**RE: Willow Creek ISL Operations, Permit No. 478, Well Acceptance Volumes
Mine Unit 10A, Modules 10-1 & 10-2, Acceptance and Inspection Results**

SUBJECT: Uranium One's Willow Creek (Christensen Ranch) Permit No.478, Mine Unit 10A, Modules 1 and 2 – Well Acceptance Inspection of December 18th, 2012

MU10A Wells – (Typical)

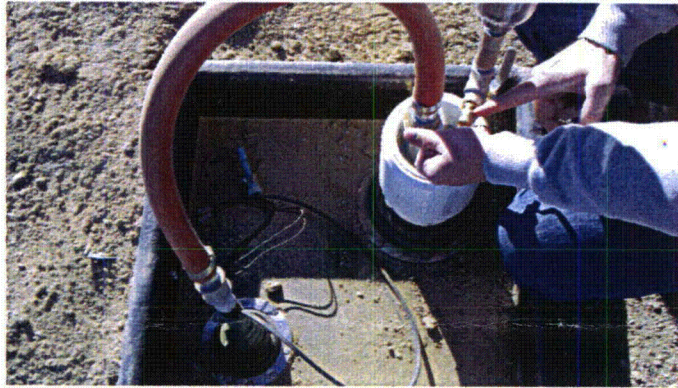
The recovery wells 10MP1 and 10MP3, adjacent shallow monitoring wells 10SM1 and 10SM2, and numerous surrounding injection wells were visually inspected (see photos). The wells were found to be in sound condition with sufficient casing above ground, completed surface enclosures, leak detection monitoring equipment in place, and wells properly identified. Wells constructed within drainages were adequately "off center" of the drainages. Additionally, the enclosures and completions are sufficiently above grade in such areas to protect the wells from precipitation/runoff events. It was noted that the surface area for runoff into the subject small drainages is also very limited.

Minor issues with erosion caused from short term air lifting and/or well purging were pointed out. Uranium One staff indicated the issues would be addressed and that final grading and seeding would also be complete in the spring of 2013. The inspection was concluded and approval of the well completion package has been made.
